RECEIPT DATE: n/a **ONSITE SEWAGE DISPOSAL SYSTEM** P 533240-A
 INSTALLATION APPROVAL DATE: 9-17-14 **PERMIT** A Repair
 (Signature: KMW)

File Review:

Breezewood Farms Lot 2 Sec 2
1701 New Hampton Lane

LOCATION DRAWING
 1701 New Hampton Lane
 Howard County, Maryland
 Election District No. 03

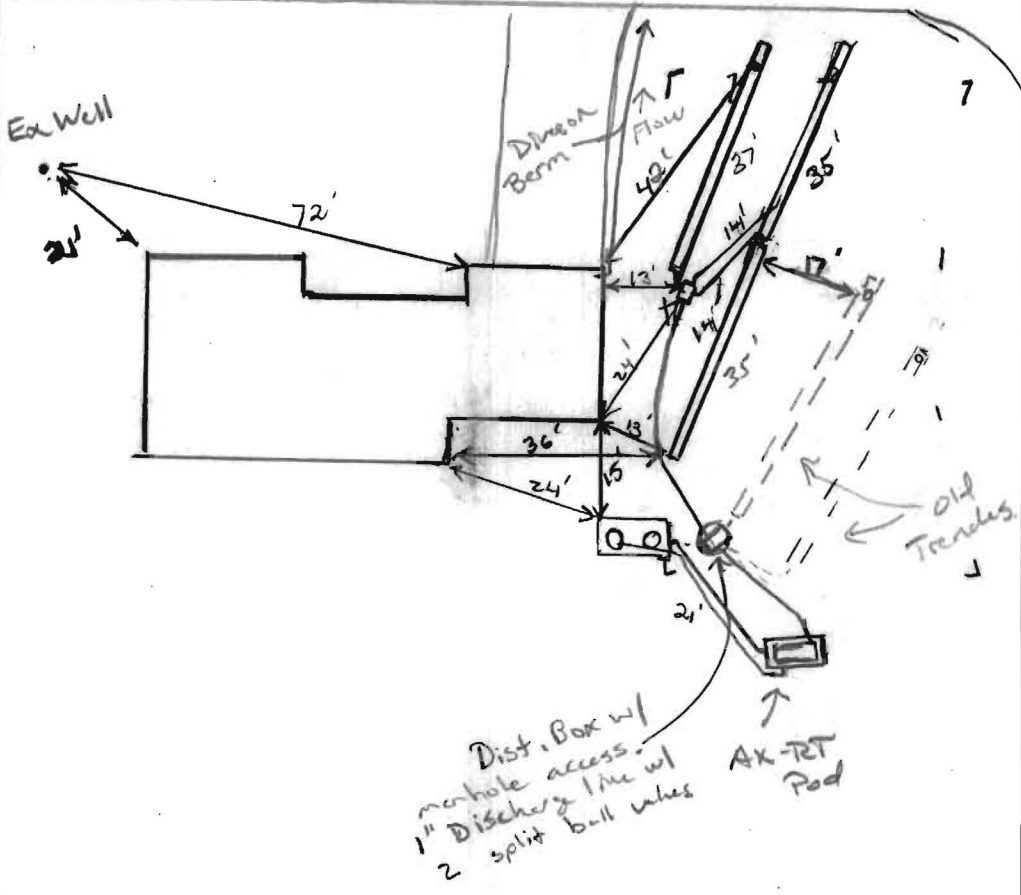
8/28/14 BAT unit installed. No Advantex rep present. Could not start unit, OK to cover work. Need start-up certification from supplier prior to approval (KW)

8/26/14 Trenches laid out. Set Dbox approx 10' off side corner of house, Run 2x35' trenches towards New Hampton Ln. and 1x35' trench in opp direction. BAT rep. not onsite also word from them as to tank delivery. (KW)

9/17/14 Met BAT manufacturer in field. start-up performed on system (KW)

PERMIT

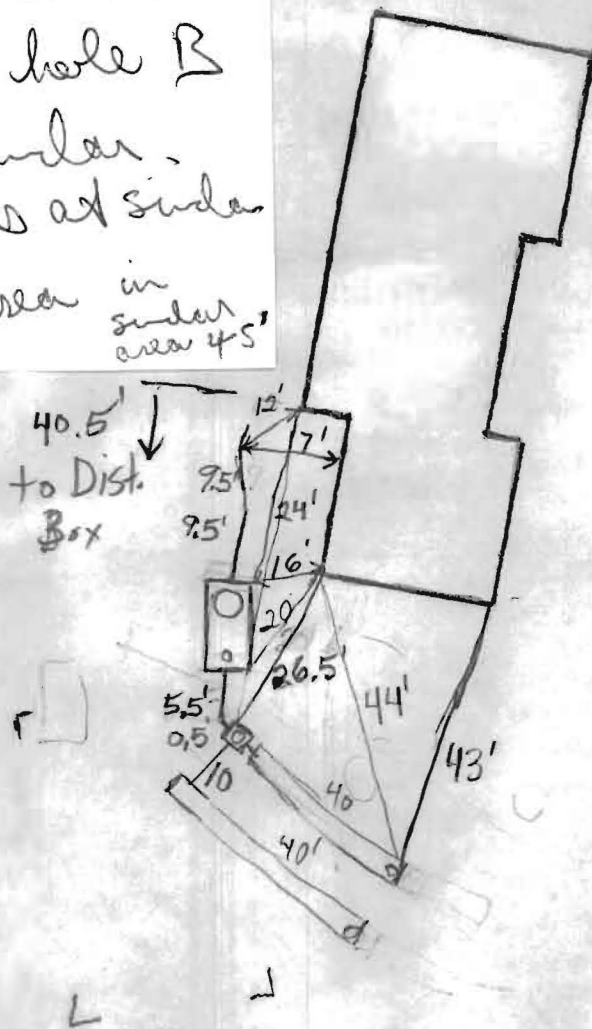
2010 test hole 5
 equivalent to
 2014 test hole B
 Both w/ similar
 perc rates at similar
 depth
 effective area in
 similar area 45'

5/21/10 Tank set 16' from house to keep trenches as far uphill as possible - Not set according to layout
